Ref: Response to CURE Data Request Set 1 for Avenal Energy (08-AFC-1)

**APPLICATION FOR CERTIFICATION
For the AVENAL ENERGY PROJECT**

**Avenal Energy AFC
(08-AFC-1)
Response to CURE Data Requests Set One**

REGIONAL TRANSPORTATION SYSTEM
Exhibit C31-1
 FEDERAL POWER AVENAL, LLC
 AVENAL ENERGY | FIGURE 6.11-1

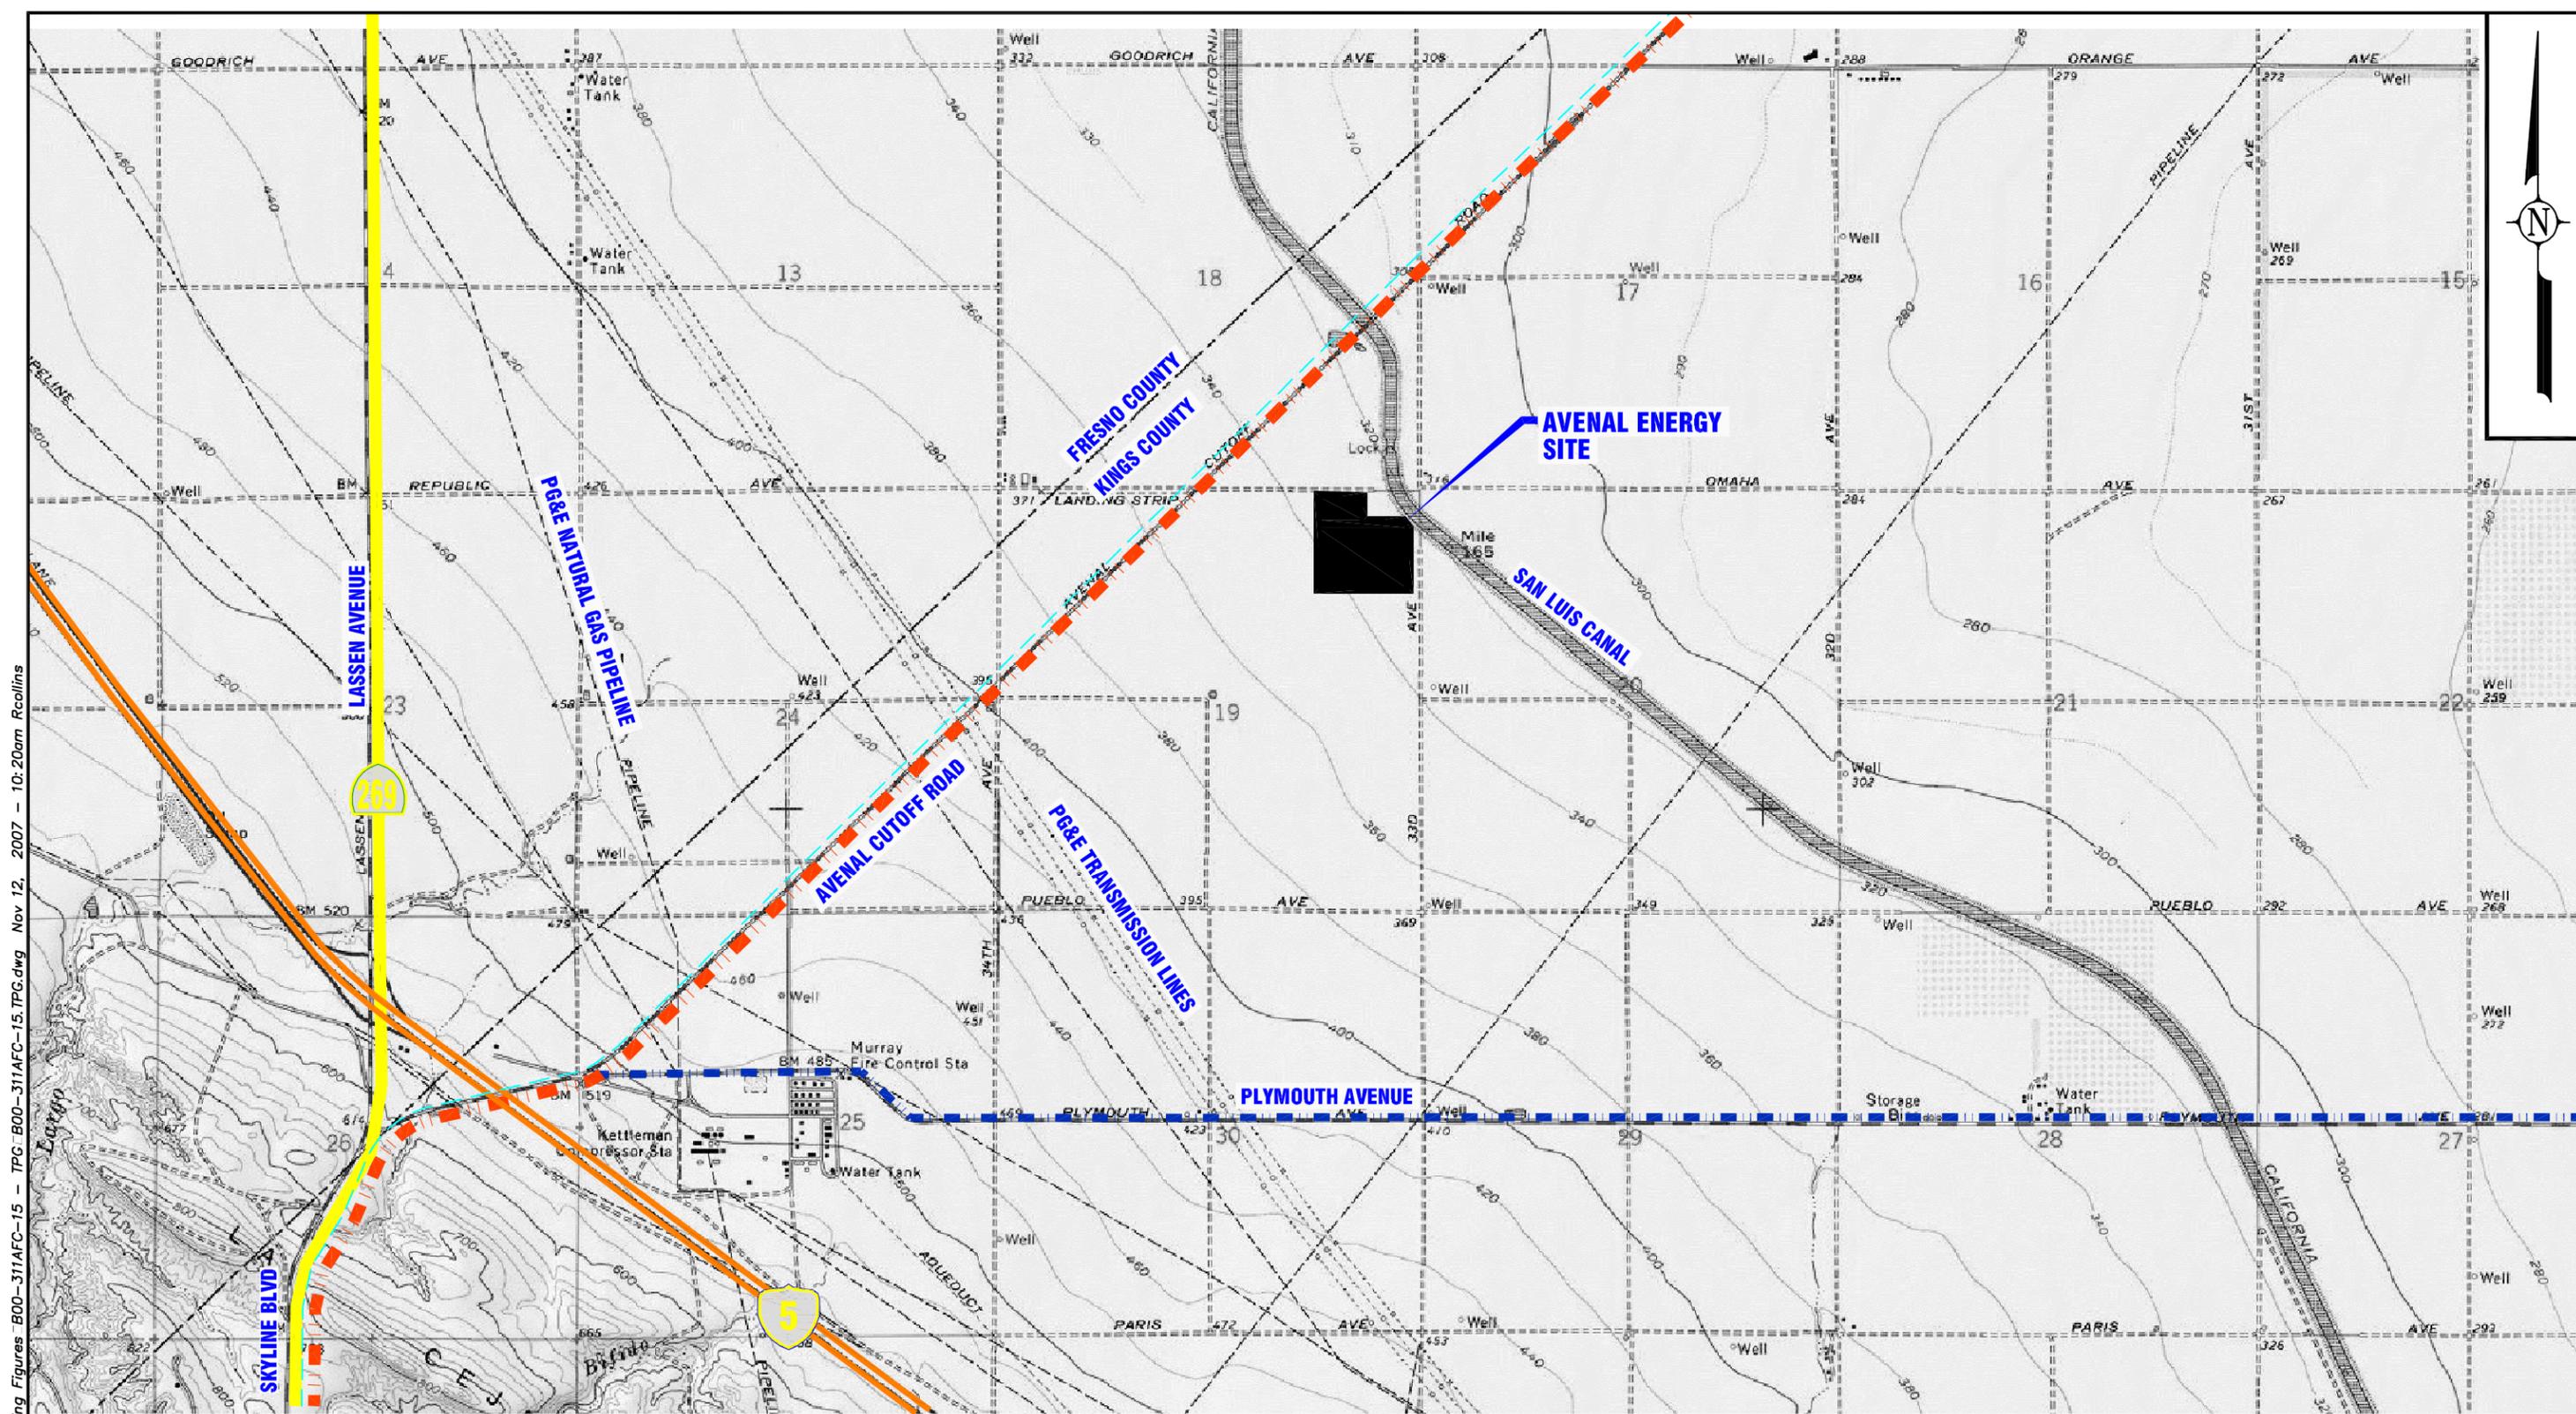
31. Please provide the figures referenced in Section 6.11.

RESPONSE
